**Camshaft Cover Oil Leaks – AJ16 Engine –
Revised Bolt Torque Specification**

MODEL 1995-96 MY
Sedan (4.0)Range
VIN
720001-767554

ILLUSTRATION 1

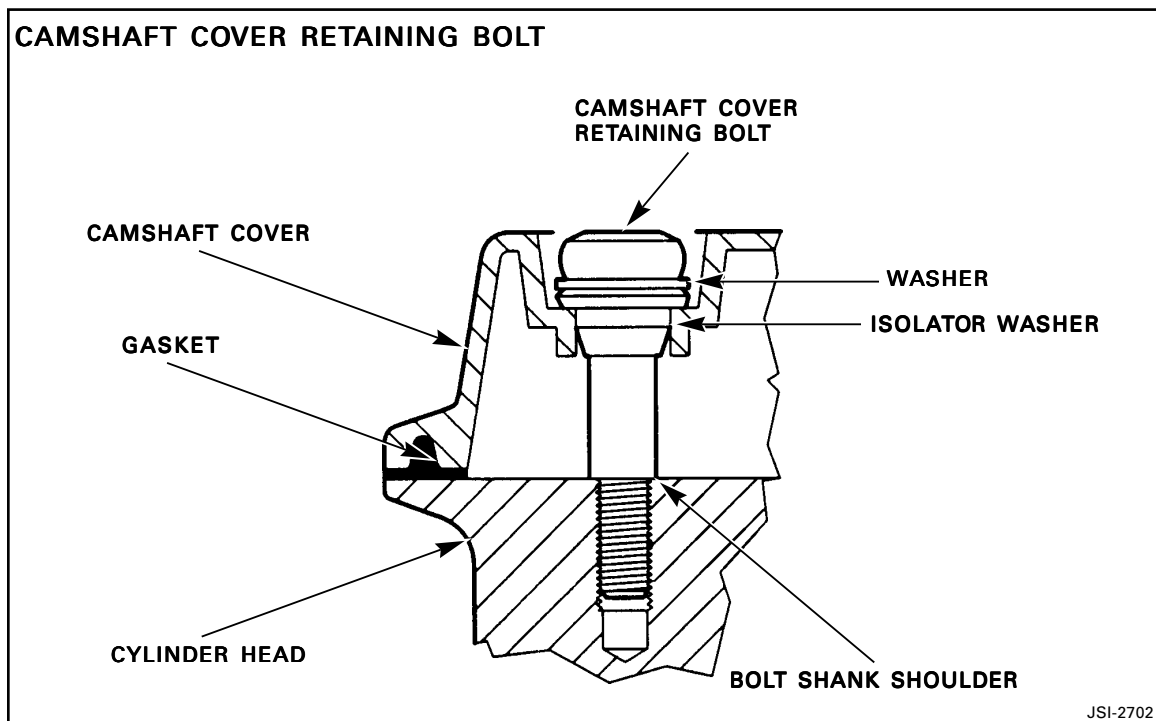
The torque specification for the camshaft cover retaining bolts has been revised beginning with VIN 767555. The revised torque specification ensures that the shoulder on the shank of the bolt bottoms against the surface of the cylinder head (Illustration 1) to achieve even compression of the camshaft cover gasket and to reduce the incidence of oil leakage.
